**Re: Dogger Bank South Project – Written representation (deadline 26/6/25)**

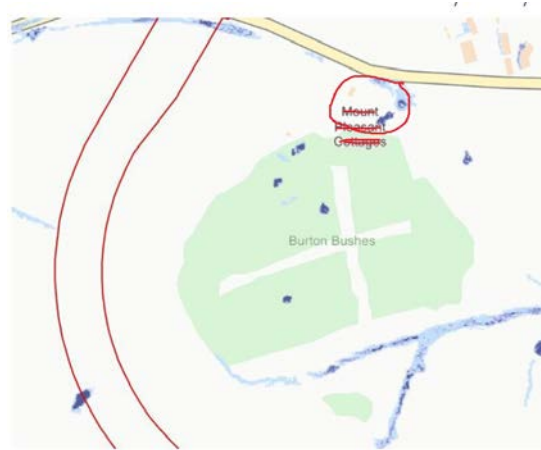
... I wish to highlight a further concern. It has come to my attention that the property Burton Gate House formerly at lat, long 53.842977, -0.464529 (which is directly adjacent to Burton Bushes) was sold and subsequently demolished in recent months (please see figure below). It appears that the land in this area is currently being prepared in some way, and a fence has been erected between this land and the part of Burton Bushes it abuts (i.e. a 0m distance).

Can the applicant confirm if they have purchased this area of land? If so, what sort of impacts might occur for the adjacent ancient woodland and SSSI due to any proposed works, temporary compounds, or activities on this recently acquired land? This proximity raises immediate concerns regarding:

- Root Zone and Soil Disturbance: The extension of root systems beyond the woodland boundary and the potential for damage or soil compaction from construction traffic.
- Changes in Hydrology: The risk of altering drainage patterns or intercepting groundwater flow, potentially impacting the woodland's soil moisture.
- Edge Effects: Increased light penetration, noise, dust, and chemical pollutants, all of which can degrade the ancient woodland habitat.
- Fragmentation and Connectivity: Hindrance of species movement if this area is going to be used for construction activities.
